ROAD SAFETY REVIEW OF TEMPORARY TRAFFIC MANAGEMENT, IN JEDBURGH TOWN CENTRE.

Report Ref 120422

Temporary Traffic Management, Jedburgh Town Centre.

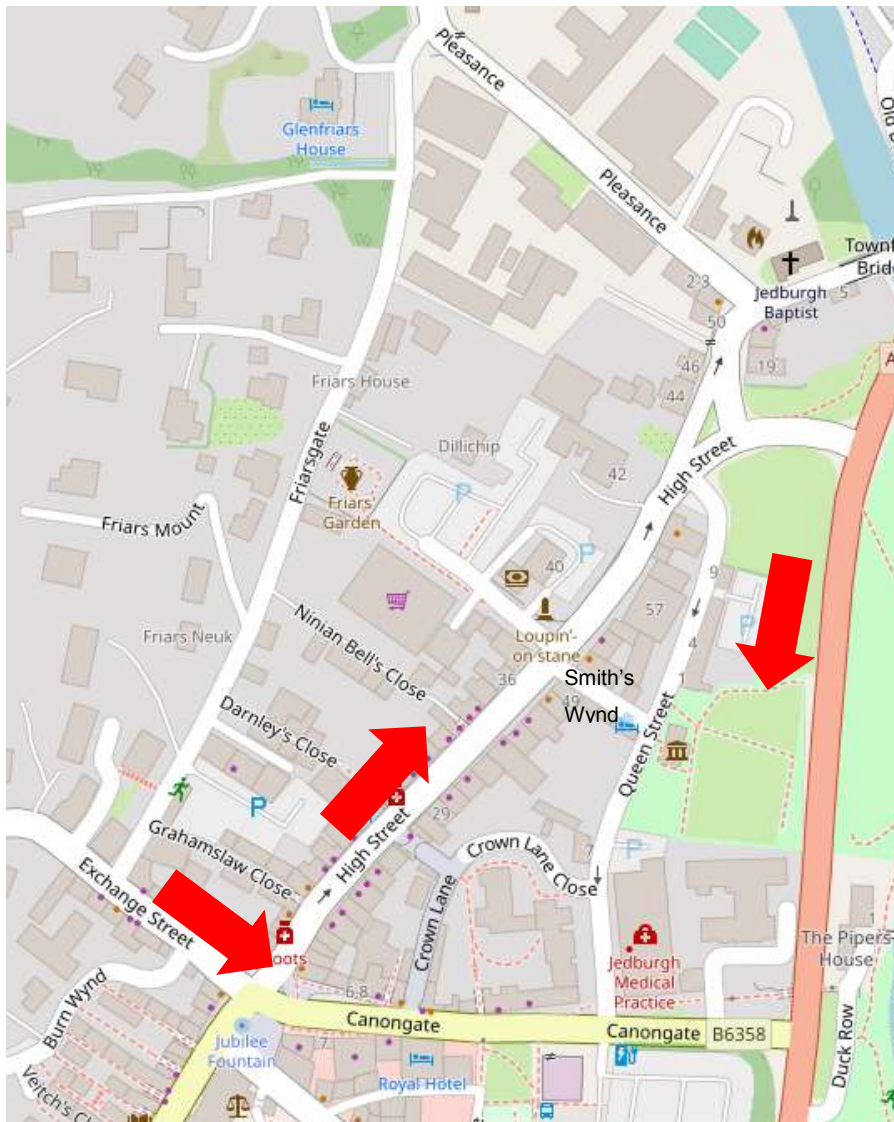
- 2.3. Currently the scaffolding limits the carriageway width of High Street to 4.4m and on Exchange Street to 3.4m over the extents of the building frontage and nearest adjacent buildings. The scaffolding removes the continuous footway connection between High Street and Exchange Street and requires pedestrians walking between both to have to cross High Street, Canongate and Market Place to reach Exchange Street.
- 2.4. The reduced carriageway widths have resulted in the council imposing temporary one-way traffic management measures in order to maintain safe access for pedestrians, cyclist and all classes of vehicles. These measures are;
- 2.4.1. High Street, one-way northbound from Exchange Street to Queen Street.
 - 2.4.2. Exchange Street, one way eastbound from Burns Wynd to High Street.
 - 2.4.3. Queen Street, one-way southbound from High Street to Smith's Wynd.
